STAFF REPORT: 02/11/2026 REGULAR MEETING

APPLICATION NUMBER: HDC2026-00004

ADDRESS: 4825 FULLERTON

SCOPE: DEMOLISH REAR TWO-STORY PORCH, ERECT REAR TWO-STORY PORCH

Photo from application of existing condition

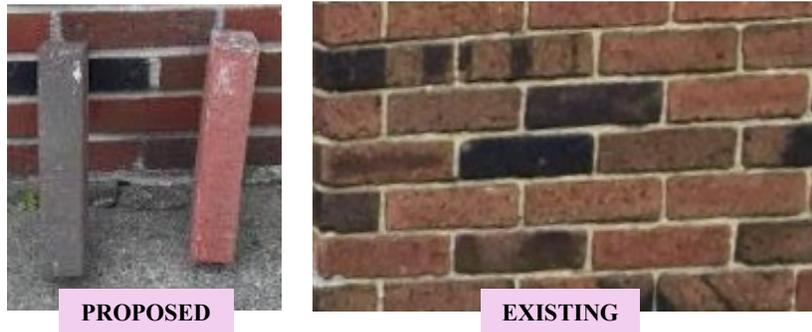
- For the brick column, the proposed brick does not match in size or color of the existing historic brick at the rear of the house.

- Considering the existing second story enclosure is likely not original and is at the rear, it is staff's opinion that the replication of the massing, style, and materiality of the proposed two-story porch is generally compatible. Additionally, it follows the National Park Services' 'The Secretary of the Interior's Standards for Rehabilitation' Standard #9, quoted below.

- The proposed column bricks are not compatible with the adjacent historic brick.

- The product information identifying the proposed replacement brick and colorway(s) and a photo of the sample new brick next to existing historic brick provided to staff for review and approval to ensure that it is compatible in texture, color, and dimension with the adjacent historic brick.
